Determination 2023/026

Regarding the compliance of part of an existing pool barrier with section 162C of the Building Act 2004

68 Clarkin Road, Hamilton

Figure 1: Plan of the pool and pool barrier (not to scale).

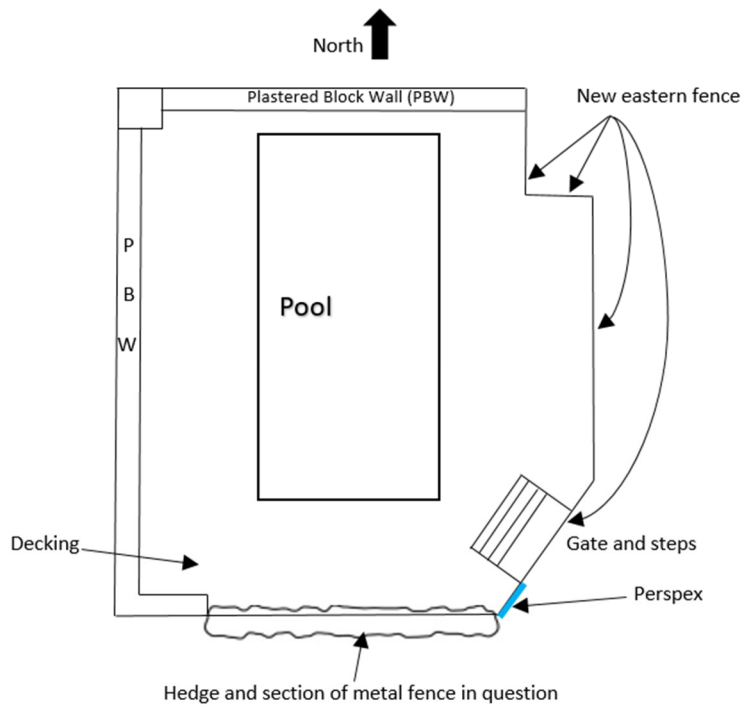
2.2. The pool barrier consists of 1.8m high plaster block walls to the northern and western sides, and 1.2m high metal fencing to the eastern and southern sides (see Figure 1). The eastern side of the barrier is constructed from vertical metal bar fencing that was installed some time in 2020. The western, northern, and eastern sides of the pool barrier are not in dispute between the parties. It is the compliance of the southern section of the barrier, which retains the original metal fencing (see Figures 1, 3 & 4), that is disputed and that forms the subject of this determination.

Figure 2: Original eastern barrier, which has since been demolished but is the same type of fencing that remains on the southern section of the barrier.

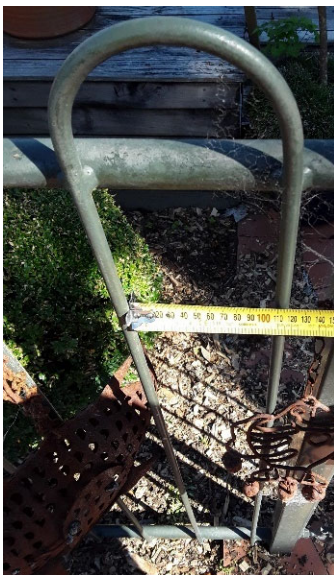
- 3.2. The authority carried out a monitoring inspection of the pool barrier on 18 March 2020.³ In its inspection report, the authority highlighted several compliance issues with the eastern side of the original barrier, including that the gaps between the vertical bars of the original metal fence exceeded 100mm in most areas.

- 3.4. Following this inspection, the owners replaced the entire eastern side of the pool barrier, including installing a new self-closing gate and a new metal fence along the eastern side. The new fence has smaller gaps between its vertical bars compared to the original barrier. As I understand it, the authority is now satisfied this eastern side of the pool barrier is compliant.
